September 5, 2017

Re: Proposed BC Hydro Pedestrian and Cycling Bridge across the Grandview Cut

**Figure 1 - Proposed BC Hydro walking and cycling bridge indicated in red.  
Protected bikeways in light green, painted bikeways in dark green  
Local street bikeways in purple**

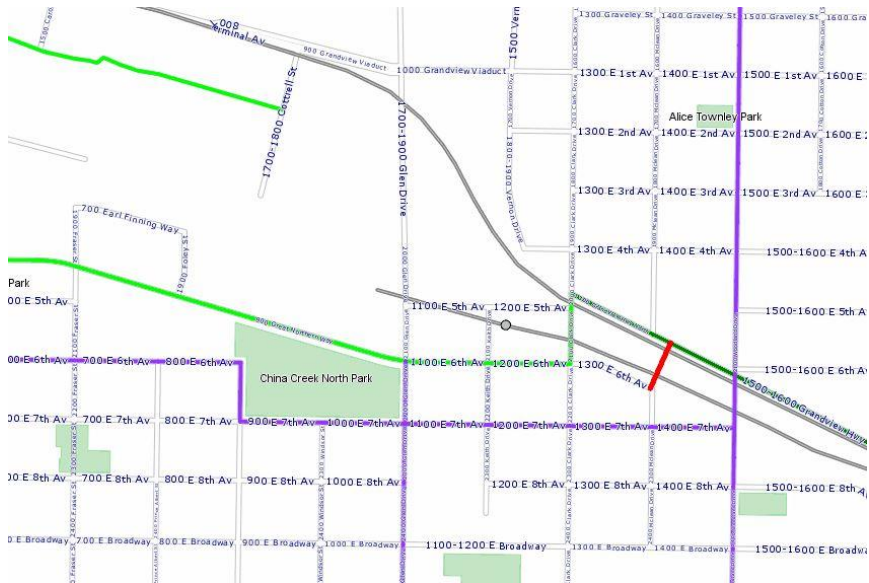
- 2) The crossing location at McLean Drive is understood to have been selected due to the existing City street right of way there. If there were other possible locations for the crossing, there may be more value to people cycling. McLean Drive has north-south cycling infrastructure both one block east, and one block west, both crossing the Grandview Cut, so this bridge appears to add little to the network. This evaluation is from a cycling perspective; there may be local pedestrian benefits.

- 3) People cycling west on Grandview Highway would have to cross Grandview Highway midblock to access the bridge. If a proposed new bidirectional cycle track was constructed on the south side of Grandview Highway by the City, this concern would be alleviated. For people cycling east, there is less concern with connecting at Grandview Highway.

- 4) For people cycling west after travelling south on the new bridge, 6<sup>th</sup> Ave. is generally usable up to Clark Drive due to the low vehicle traffic volumes. However, crossing Clark is problematic. There are a high number of eastbound motor vehicles turning north, so crossing Clark Drive would involve three crosswalks. The City is considered unlikely to change this intersection due to the number of vehicle turning movements.

- 5) For people cycling west on Grandview Highway and wanting to access the 7<sup>th</sup> Ave. local bikeway, using Woodland represents a shorter distance and so the new bridge adds little.
